BRACKET UPGRADE INSTRUCTIONS AND INSTALLATION

The Original HEPA filter for TurboJet Max Series, Sentinel 1500 and TurboJet 2012 has been upgraded to a new extruded aluminum frame for a more rigid and durable product.

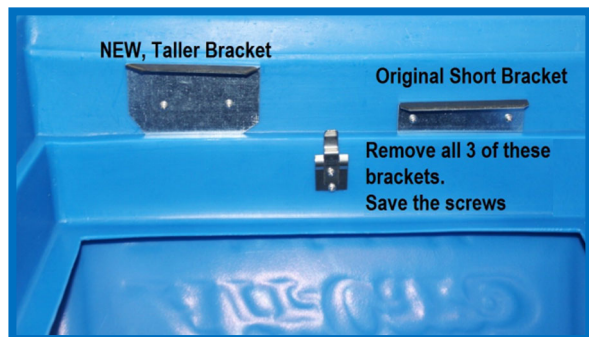
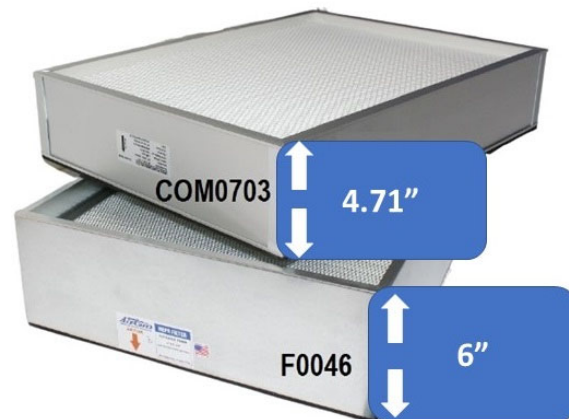
The Original F0046 18x24x6" filter is now the new COM0703 18x24x4.71". Filtration is unchanged at 99.97% for particles over 0.3 μ .

The flex filter will still be installed in the top of the frame of the COM0703 as it was in the F0046. The interior brackets are not long enough to support the new filter, so they will need to be replaced.

The part number for the new part is SA0060, 3 will be required for each machine to replace the original shorter brackets.

1. Locate the new bracket with its edge flush to the step in the TurboJet case.
2. Move the bracket side to side to cover the holes of the original bracket.
3. Use the screws removed from the old brackets and a Phillip's screwdriver to mount the new bracket as shown. **DO NOT OVER TIGHTEN THE SCREWS**
4. Repeat this step for all 3 bracket positions.

5. When the top cover is closed, with the new HEPA in place, the HEPA should be held firmly in position so the bottom gasket will seal properly.
